**SUBJECT: Friends Recycling, LLC
Marion County - SW WACS #21012
Friends Recycling - C&D Disposal and Recycling
Response to First Request for Additional Information
Permit Application No. 0019600-008-SO-24**

PERMIT RENEWAL OF C & D DEBRIS DISPOSAL FACILITY

RESPONSE TO RFI FROM FDEP DATED MARCH 1, 2013
FRIENDS RECYCLING C & D DISPOSAL AND RECYCLING
Marion County - SW WACS #21012
Permit Application No. 0019600-008-SO-24

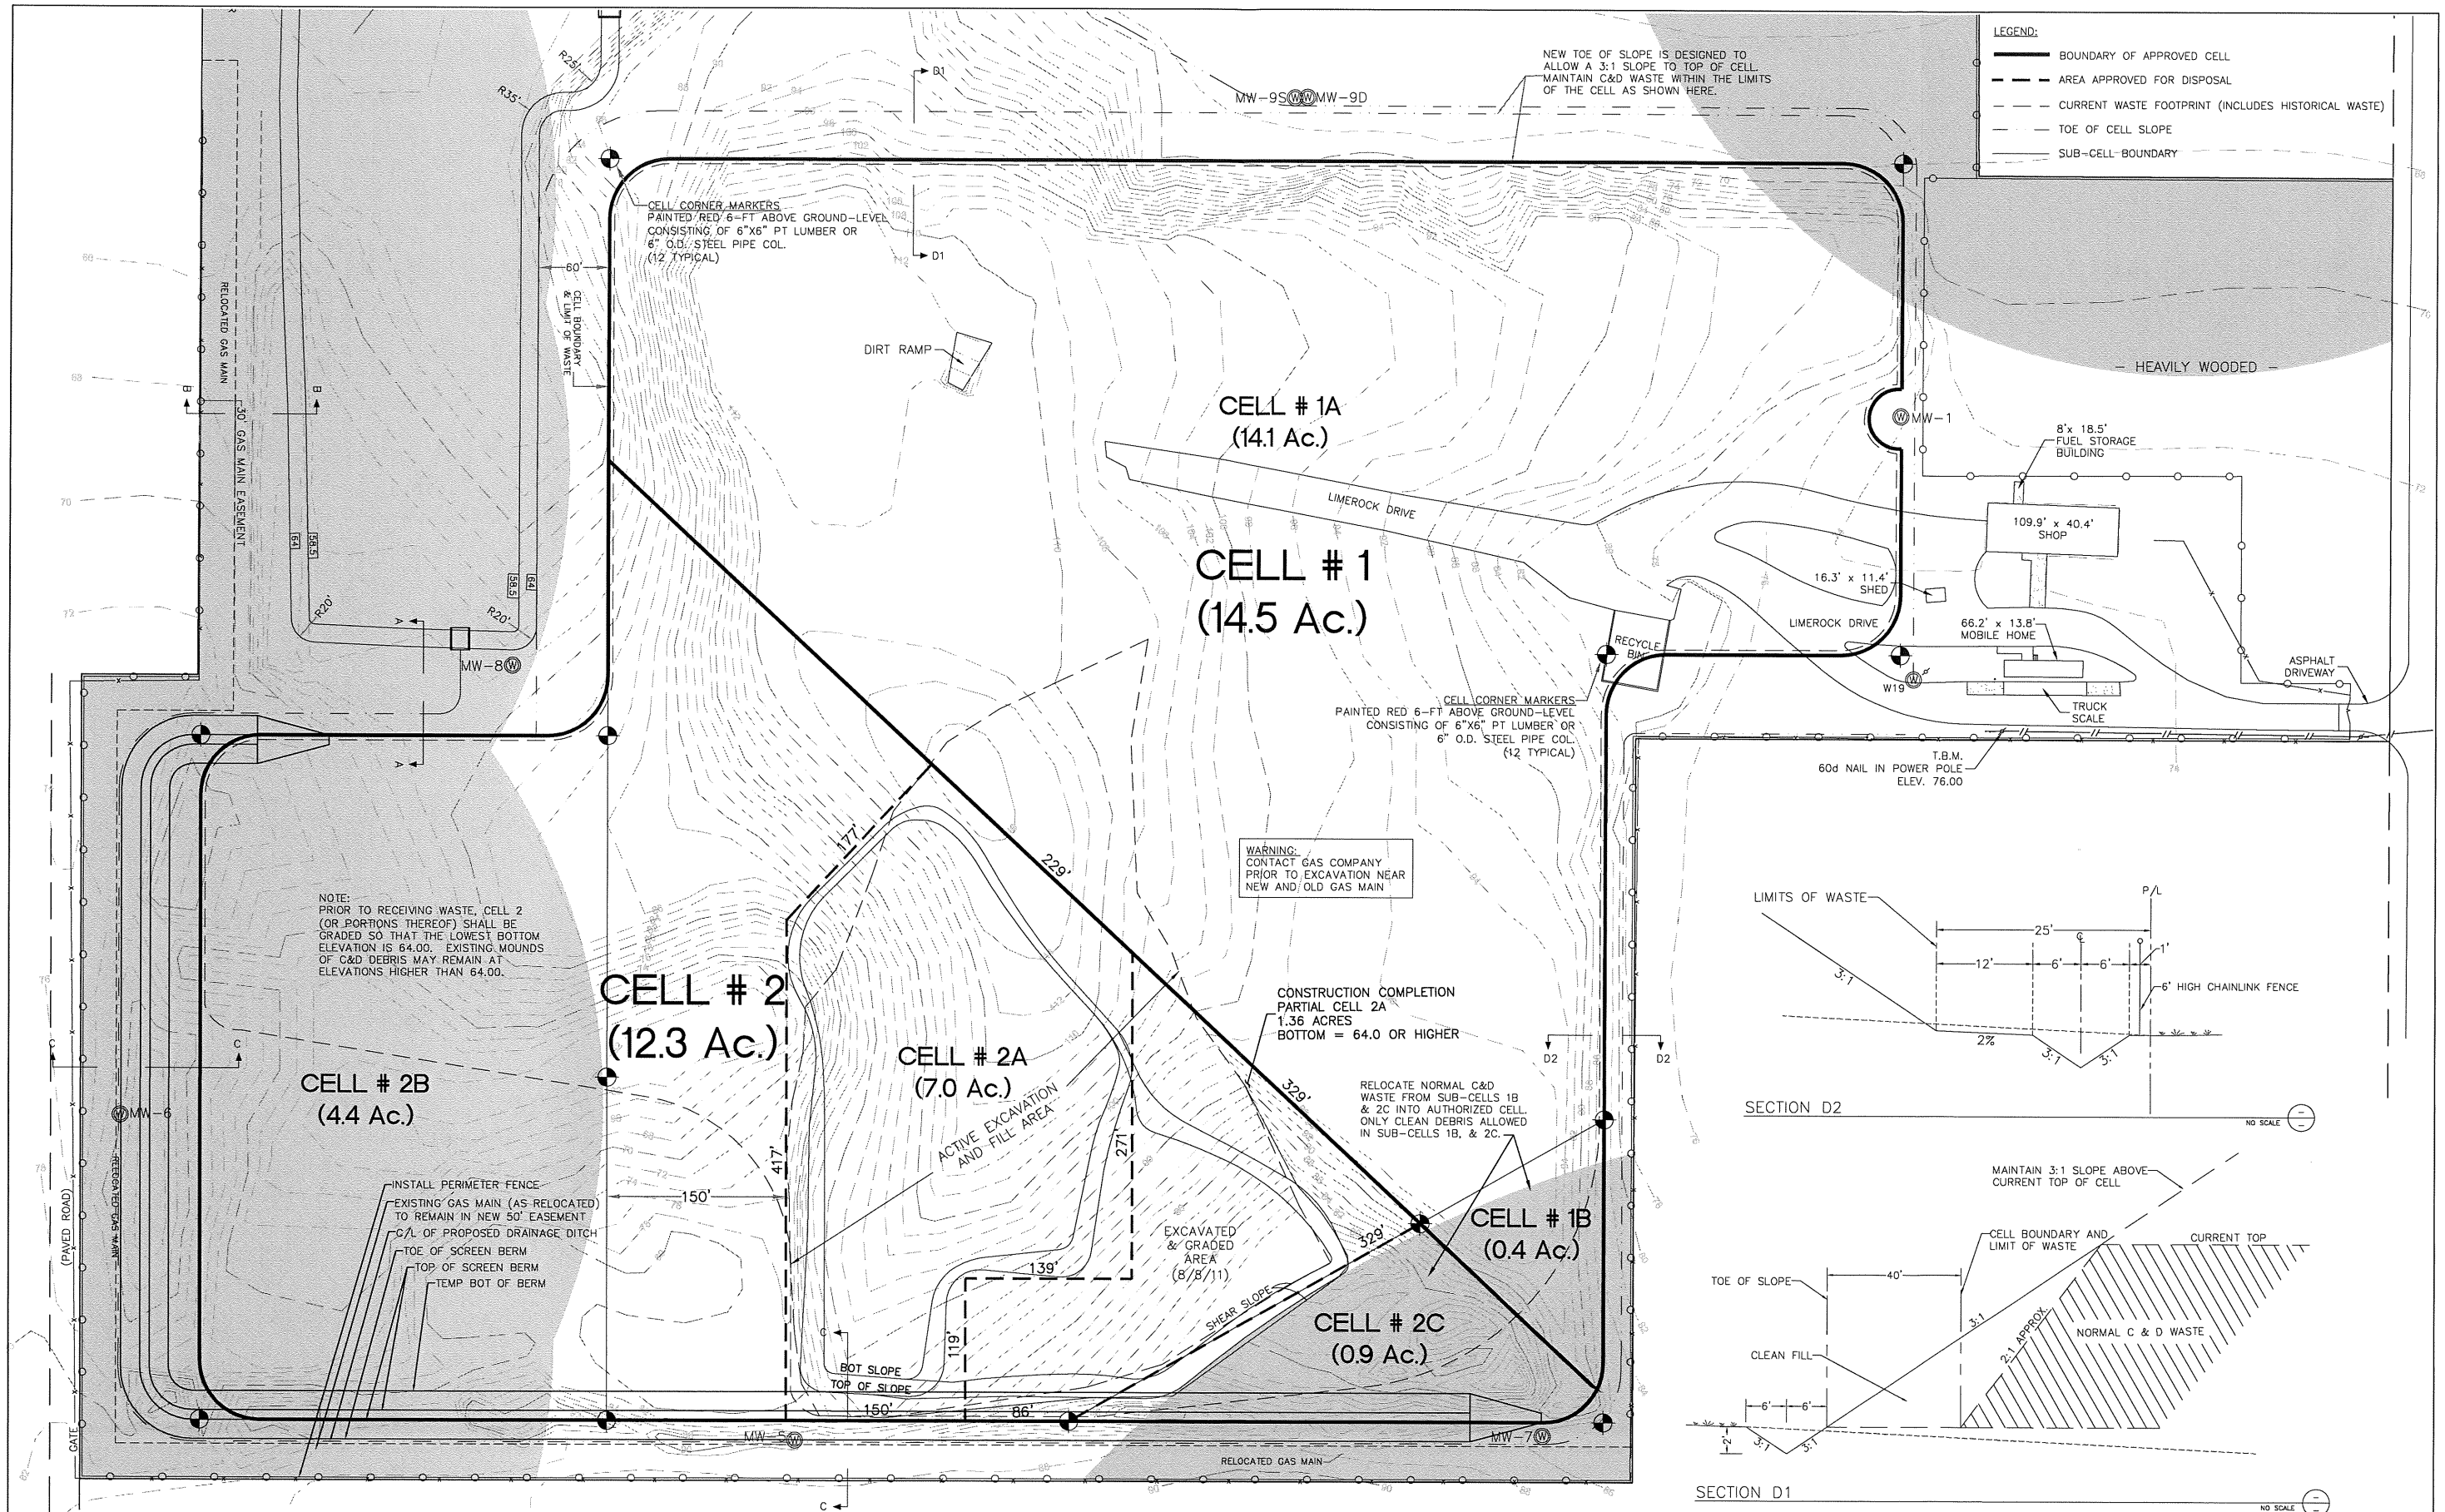
b. Notes 2, 3 and the note in the middle of Cell #1 refer to "clean waste." The Department does not recognize the term "clean waste." Throughout the Report, this fill area is referred to as receiving "clean debris." It is the Department's understanding that these notes should read "clean debris." If you agree, when you revise this drawing ensure the words are changed to "clean debris." If not, please clarify what is meant by "clean waste."

c. There are multiple dashed and solid lines on the drawing. Provide a legend for the different lines.

d. A dashed line inside of the thick solid line is labeled "current waste footprint (typ)." This implies that waste has been approved and disposed in this area. This line also encompasses areas only approved for clean debris disposal, not waste. Waste has only been approved for disposal in the Sub-cell 1A and a portion of Sub-cell 2A. (A 1.36-acre area was approved on August 17, 2011. A 2.77-acre area was approved on March 3, 2009. Those two areas are properly depicted on Drawing Sheet 5 as Sub-cell 2A, "Active Excavation and Fill Area." A triangular area of Sub-cell 2A that had already been cleared and already contained waste was approved to receive more waste on October 24, 2008.)

e. Note 4 states "Cell Corner markers shall be installed prior to sub-cell receiving waste." The drawing should have different symbols for "installed" and "to be installed" corner markers.

Response: "Clean waste" in this context means "clean debris". Sheet 2 of 7 has been revised to replace "clean waste" with "clean debris" on notes #2 & 3 as well as on the note in the middle of Cell #1.

Response: The different dashed lines are intended to differentiate between distinctly authorized disposal areas. A note has been added to sheet 2 of 7 to help identify the meaning of the lines.

Response: Because the facility has undergone ownership change no less than three (3) times and there is historical waste, there was confusion at our pre-application meeting in your office as to where the actual limits of waste were. I understood that we were asked to show what we believed the limits of waste to be (regardless of who or when it was placed).

Response: The areas which have not received ANY waste are identified as the difference between the "thick line" depicting the approved cell boundary, and the "thin dashed line" labeled "current waste footprint".

By inspection of these lines on sheet 2 of 7 you will notice that the areas which have not received any waste are the southern portion of sub-cell 2B, the southwest corner of sub-cell 2A and the southeast corner of sub-cells 2C and 1B.

Response: There is no difference since corner markers depicted on the revised sheet are installed as of the date of this response.
